From: Seattle Design Commission

Date: September 17, 2014

Subject: Seattle Design Commission recommendations for the Portage Bay Bridge and Montlake Lid components of the SR 520 Replacement Project

SDC recommendations for the Portage Bay Bridge and Montlake Lid

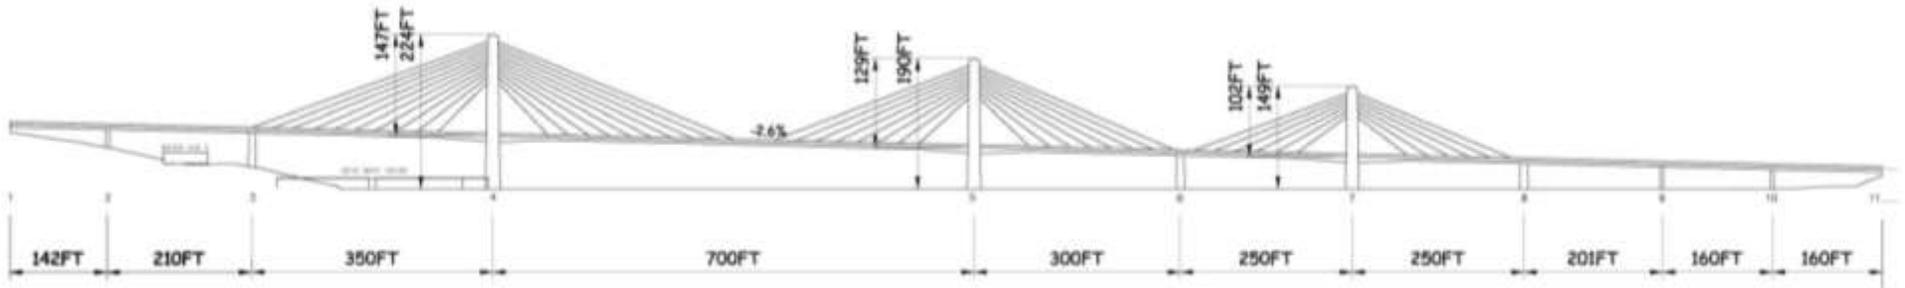
We recommend that the State and City explore the idea of retaining part of the ramps to nowhere. They are located where plans are underway to expand recreational use as part of the Arboretum North Entry project. There is an important opportunity to enrich that design of that project with these socially significant relics of the past.

July 8, 2014 – three towers of varied heights (102, 129, and 147 feet above bridge deck) and uniform 2.6% grade

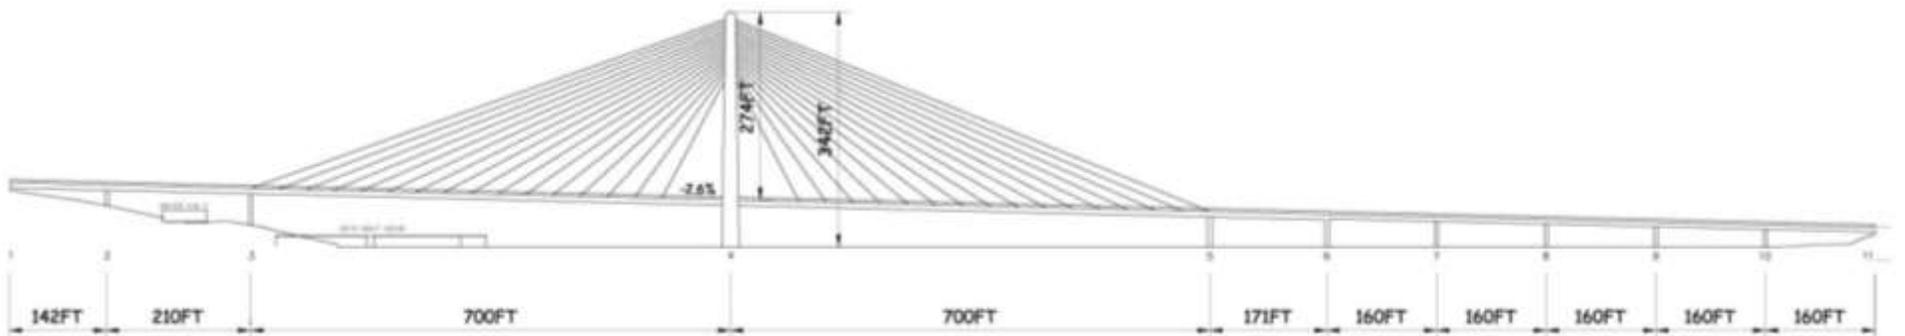
After careful analysis, the SDC believes a cable stay bridge is not the most compelling option for Portage Bay. A small number of Commissioners felt that the time allotted for the study did not allow for a full exploration of cable stay options and that a concerted effort here could result in an appropriate design. However, weighted against other bridge types and project considerations, the majority of Commissioners believe a cable stay bridge to be the least appropriate of those presented in this study.

- Maximize the cable stay technology to significantly reduce the profile of the bridge deck, size of vertical elements, and number and girth of columns in the water. The bridge should be as thin and light on the water as possible. Take great care not to create a structure that overwhelms the scale of the Portage Bay bowl.
- Leverage the bridge technology to create a dynamic and elegant formal solution to the design.
- Design the bridge lighting with consideration for the residents in the area and with the aim of elegance rather than drama.
